Access Compliance Report

Public Rights-of-Way

(Curb Ramps)

Intersection ID: 43921	Main Street: TORINGDON_WY	Cross Street: JOHNSTON_RD	Location: E
ADA ID: F4B37E34DA71	Ramp Type: PerpDiag	Initial Pass/Fail: Fail	Overall Compliance: No
Severity Score: 21.25			
Codes/Mitigation Info/Possible Solution		Field Measurements/Component Compliance

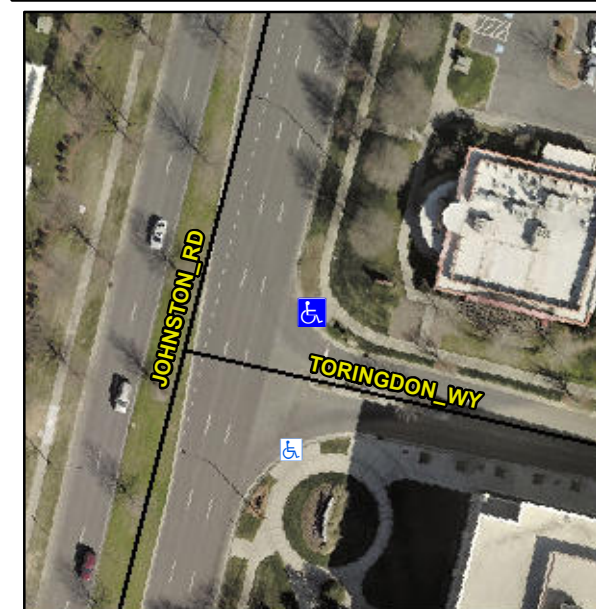
Not Found, R304.5.1, R304.2.2

Compliance	Description	Data	Compliance	Description	Data
N/A	Ramp Length (in)	112.0	No	Ramp Slope (%)	8.5
No	Ramp Width (in)	46.0	Yes	Ramp XSlope (%)	0.9
N/A	Flare Type LT	N/A	N/A	Flare Type RT	N/A
N/A	Flare Slope LT (%)	N/A	N/A	Flare Slope RT (%)	N/A
N/A	Flare Traversable LT?	N/A	N/A	Flare Traversable RT?	N/A
N/A	Landing Length (in)	N/A	N/A	DWS Provided?	N/A
N/A	Landing Width (in)	N/A	N/A	DWS Contrast?	N/A
N/A	Landing Slope (%)	N/A	N/A	DWS Length (in)	N/A
N/A	Landing X Slope (%)	N/A	N/A	DWS Full Width?	N/A
N/A	Landing Curb? (Y/N)	N/A	N/A	DWS Offset (in)	N/A
N/A	Shared Landing?	N/A			
N/A	Gutter Ponding?	N/A	N/A	Gutter Slope (%)	N/A
N/A	Gutter Lip Ht (in)	N/A	N/A	Gutter X Slope (%)	N/A
N/A	Painted X Walk1?	No	N/A	Painted X Walk2?	No
	X Walk 1 Direction	To NW		X Walk 2 Direction	To SW
N/A	X Walk 1 Width (in)	N/A	N/A	X Walk 2 Width (in)	N/A
	X Walk 1 Slope (%)	0.9		X Walk 2 Slope (%)	0.6
	X Walk 1 X Slope (%)	1.2		X Walk 2 X Slope (%)	1.9

Remove & Replace Curb Ramp With Two New Directional Ramps or Equivalent.
